**1140 Terry Fox Drive  
Transportation Impact  
Assessment**

Final Report

Stantec Consulting Ltd.

## Appendix B COMMENT RESPONSE CORRESPONDENCE

### Figure 2 - Site Plan

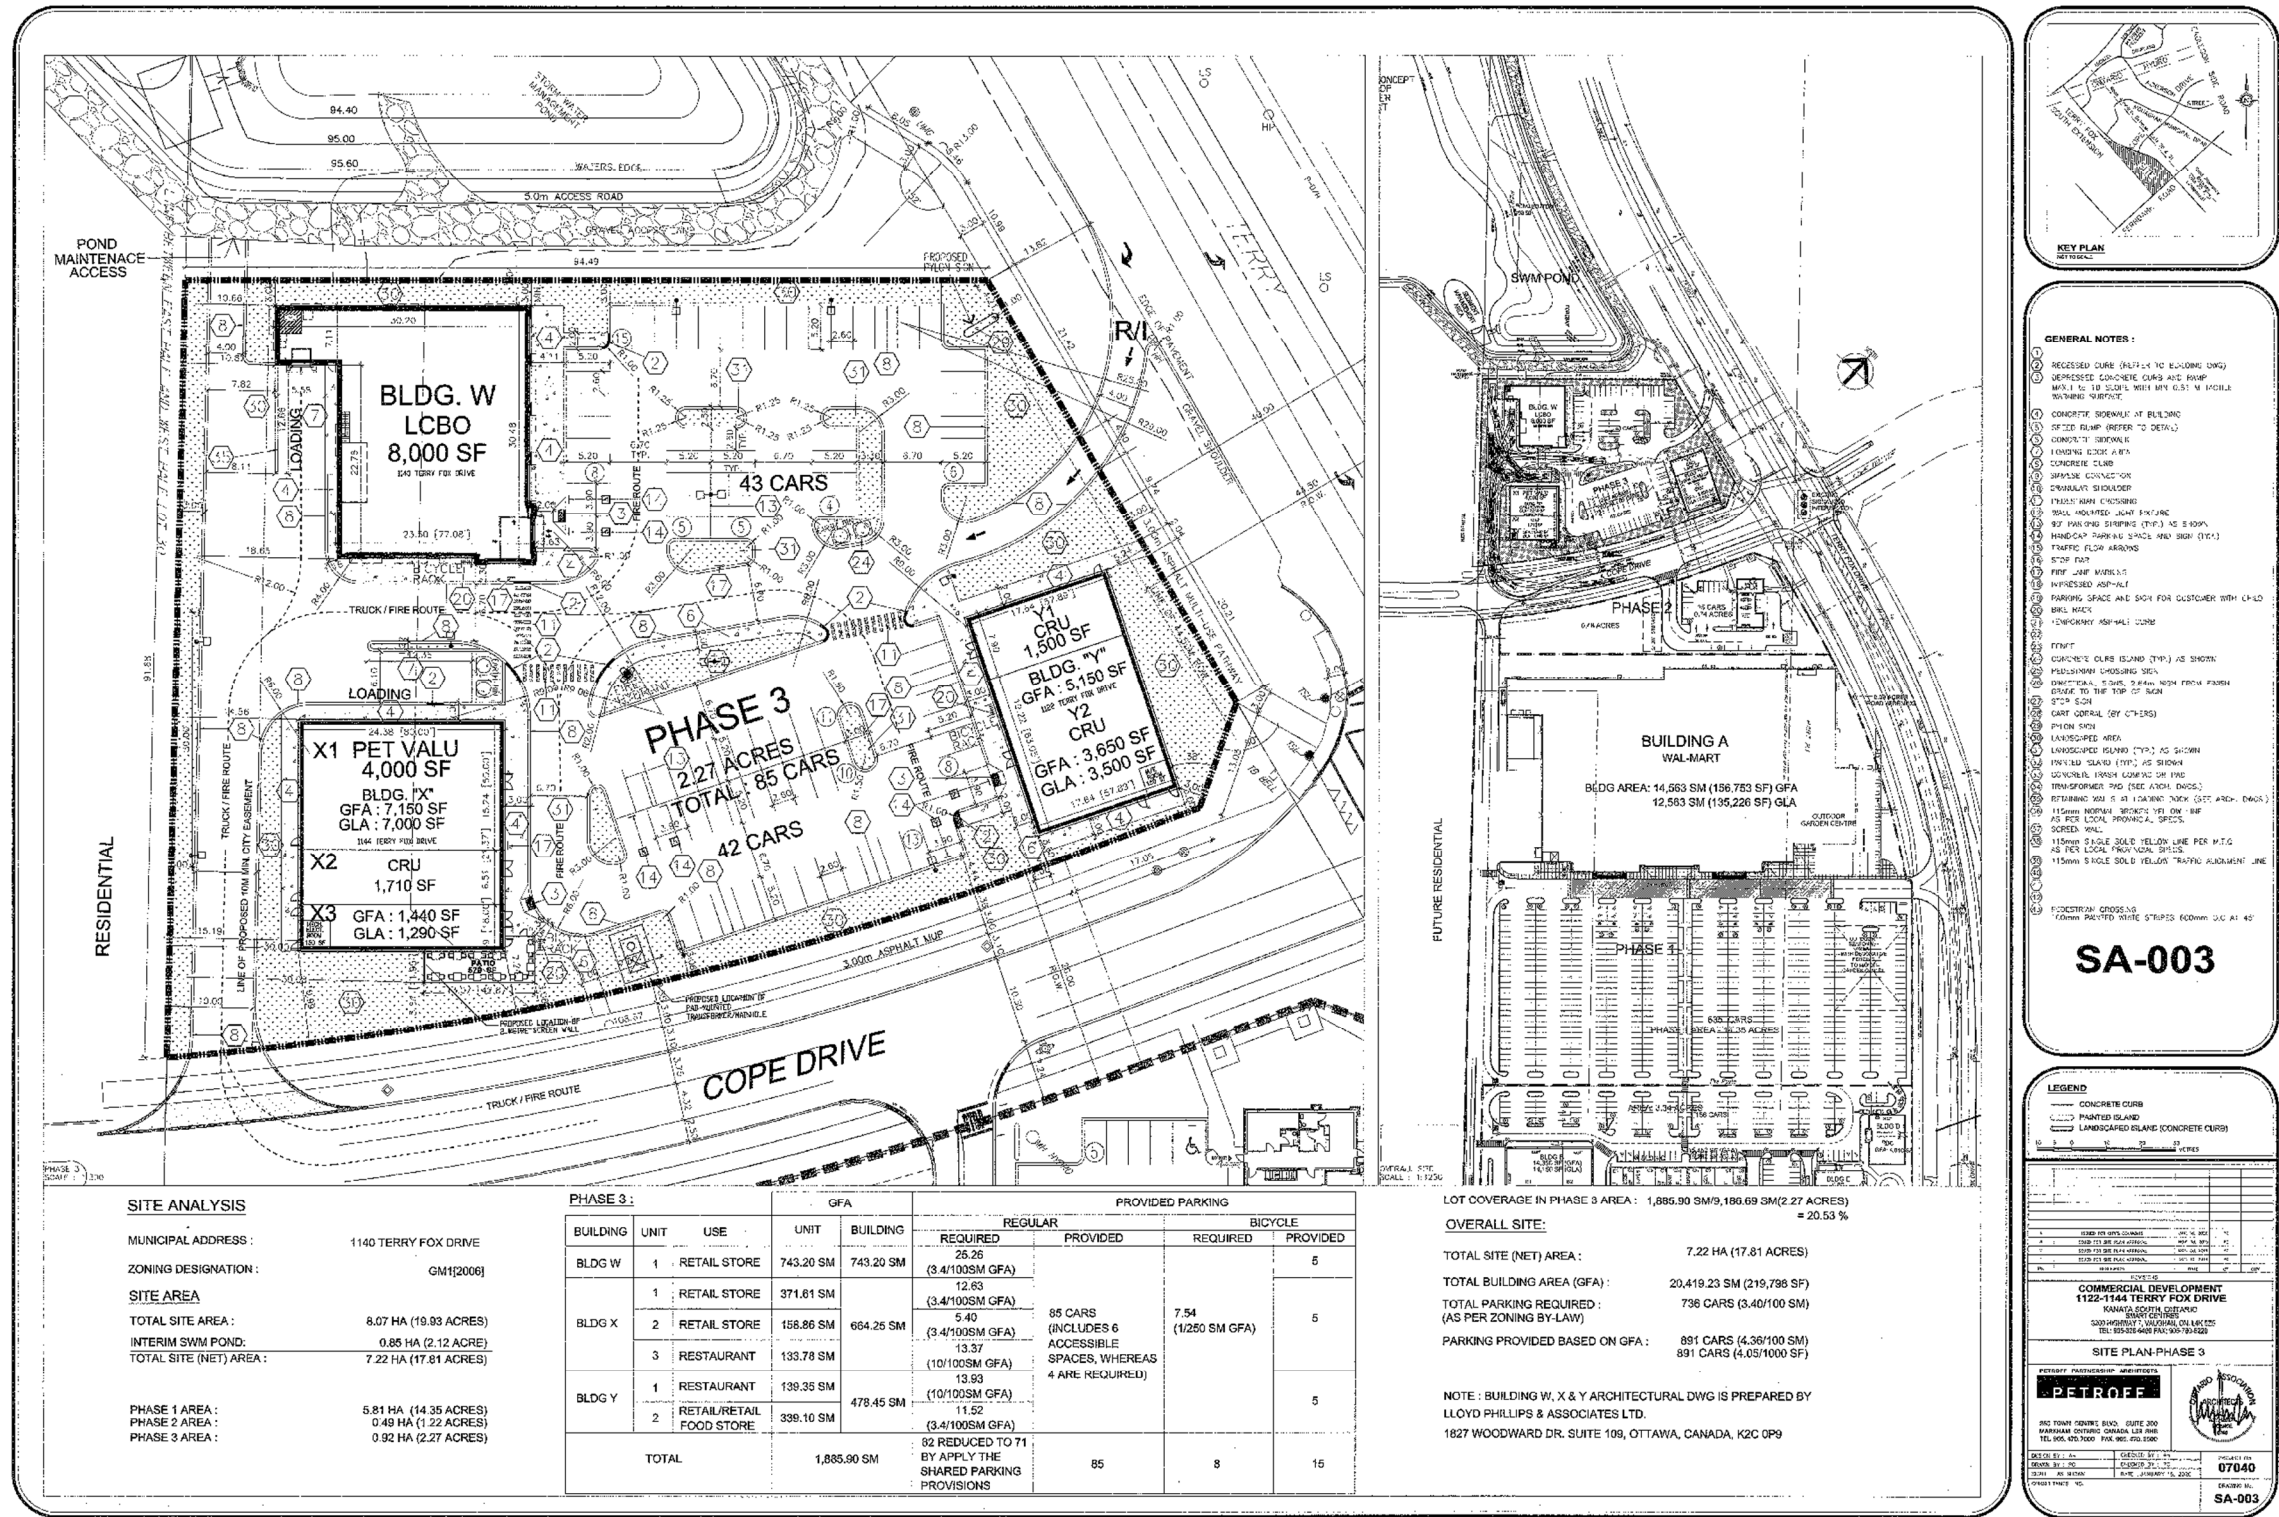
1. Regarding Figure 2 (Site Plan): The proposed right-in access from Terry Fox Drive is not preferred. Further analysis may determine that a physical restriction is required to control the access. In addition, special attention is required for addressing the MUP crossing of this access. Discussions are underway between the City and Stantec regarding this access. The width of the access will be reduced (it does not need to accommodate WB-20s nor fire trucks) and it will also likely be pushed further north. A revised site plan is coming shortly and will be sent to Rosanna for comment.

**Figure 5 - Study Area Transit Routes and Stops**

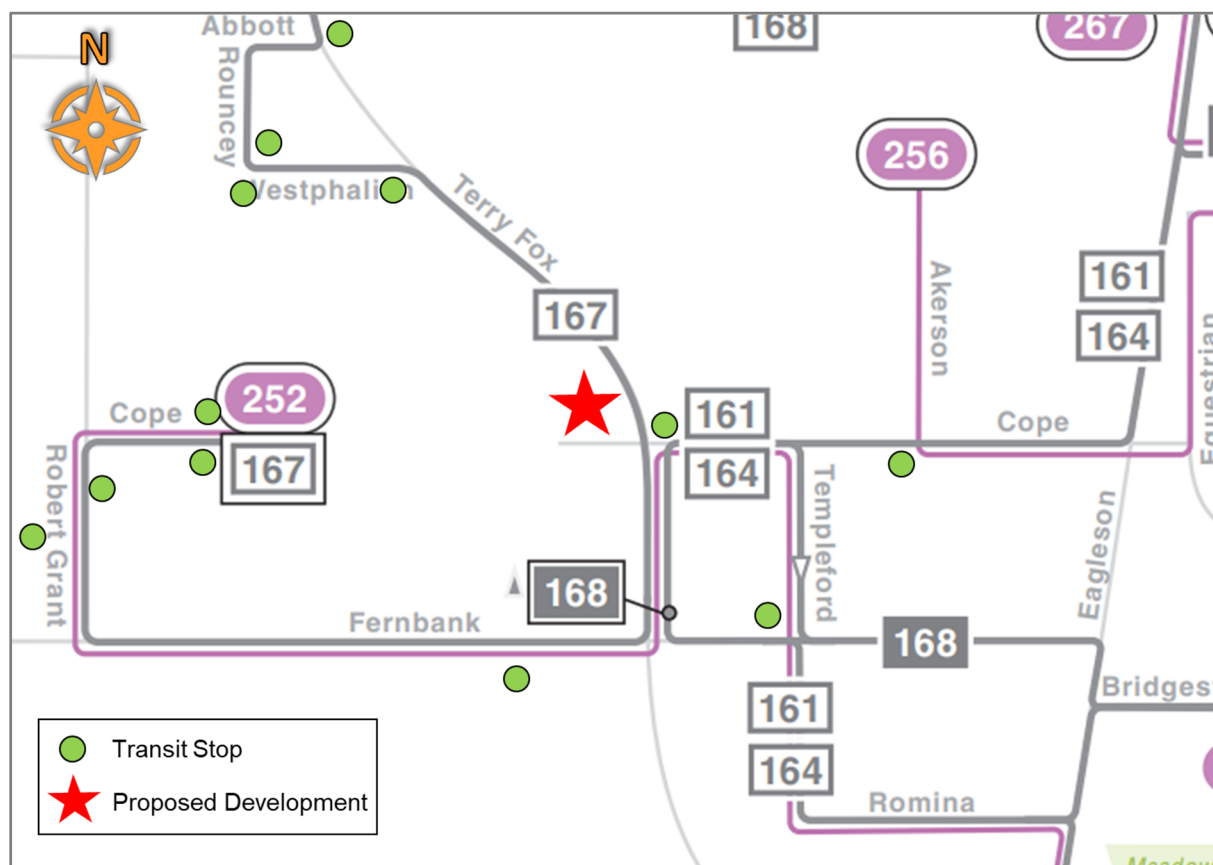
4. Ensure Terry Fox Drive is protected for a 44.5m ultimate right-of-way per the City of Ottawa Official Plan. **Noted.**
5. 2.1.2.3: Include a description of Route 161. Amend Figure 5 to illustrate existing stops on Cope Drive east of Terry Fox Drive, and on Templeford Avenue. **Noted. Section 2.1.2.3 will be revised as part of Step 4.**

Figure 7 - Location Breakdown of Rear End Collisions on Terry Fox Dr. between the Trans Canada Trail and Cope Dr. from 2014 to 2018

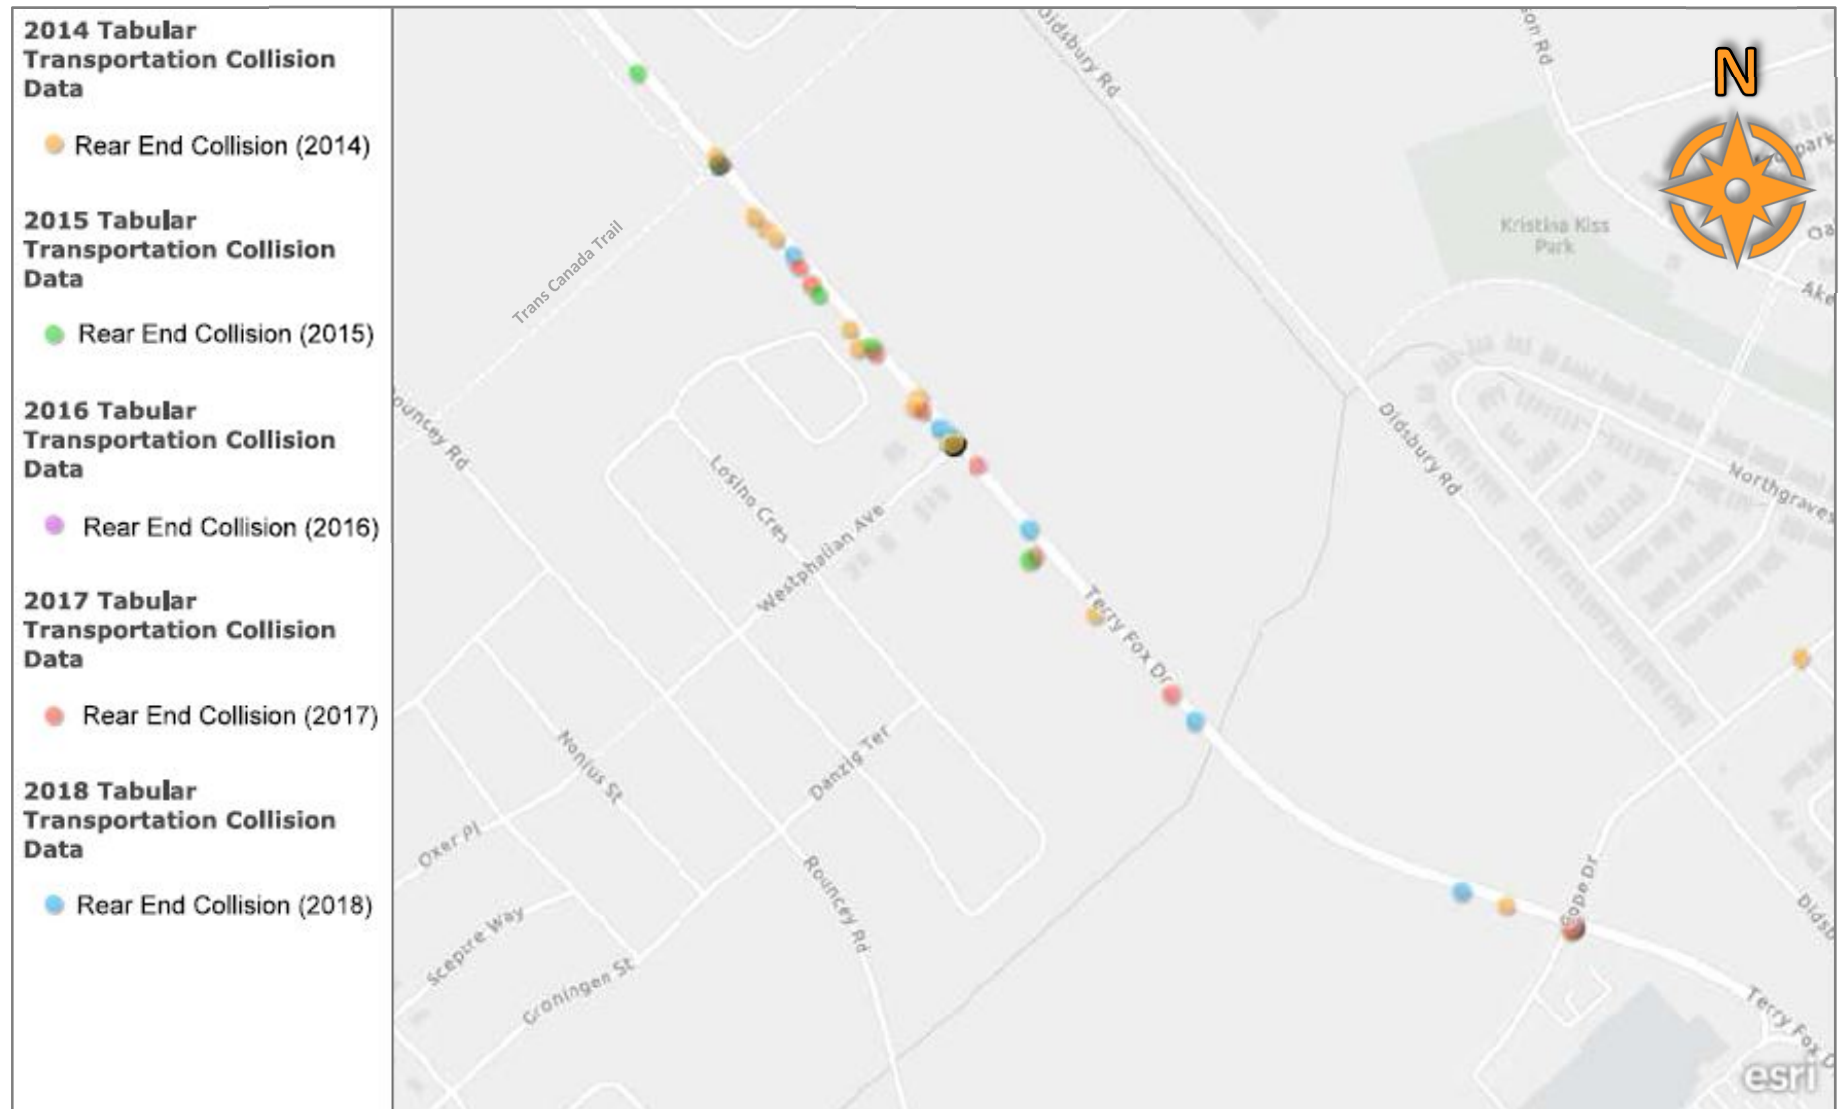
6. 2.1.2.6: Include a directional and location breakdown of rear end collisions on Terry Fox Drive between the Trans Canada Trail and Cope Drive. **Noted. Section 2.1.2.6 will be revised as part of Step 4.**

Figure 9 - Background Developments Key Plan

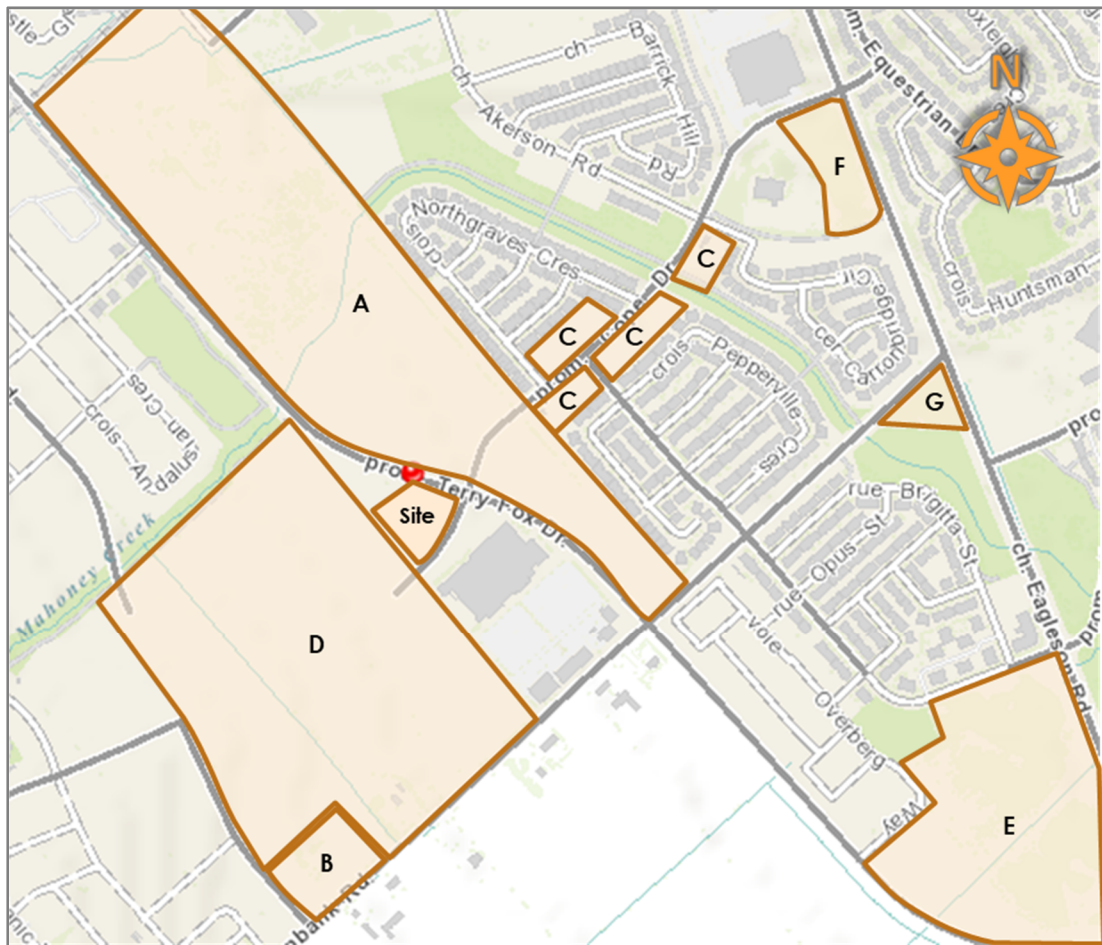
7. 2.1.3.2: In Figure 8, the extents of Blackstone Phases 4-8 (D) and the Van Gaal lands (E) are not accurate. Please revise this figure. **Noted. Figure 8 will be revised as part of Step 4.**

**Figure 10 – Pass-By Trips**

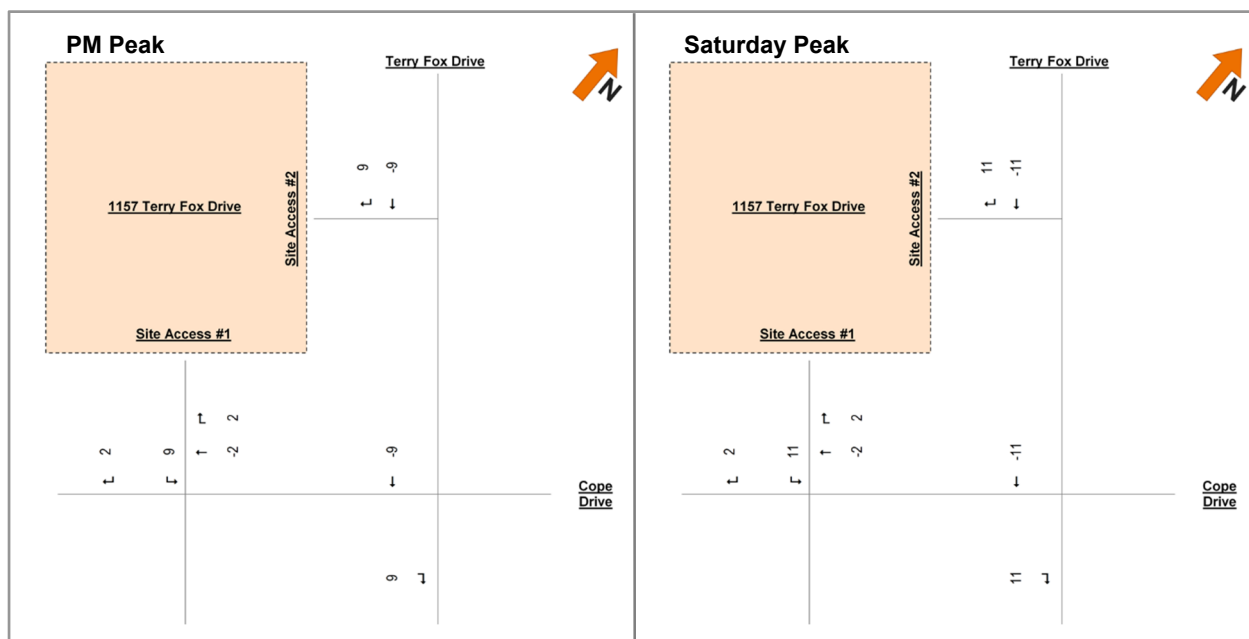
9. 3.1.2 Pass-By: PM pass-by 'In' trips in Table 10 do not match Figure 9. Likewise, Saturday 'Out' trips in Table 10 do not match Figure 9. **Noted. These figures will be revised as part of Step 4.**
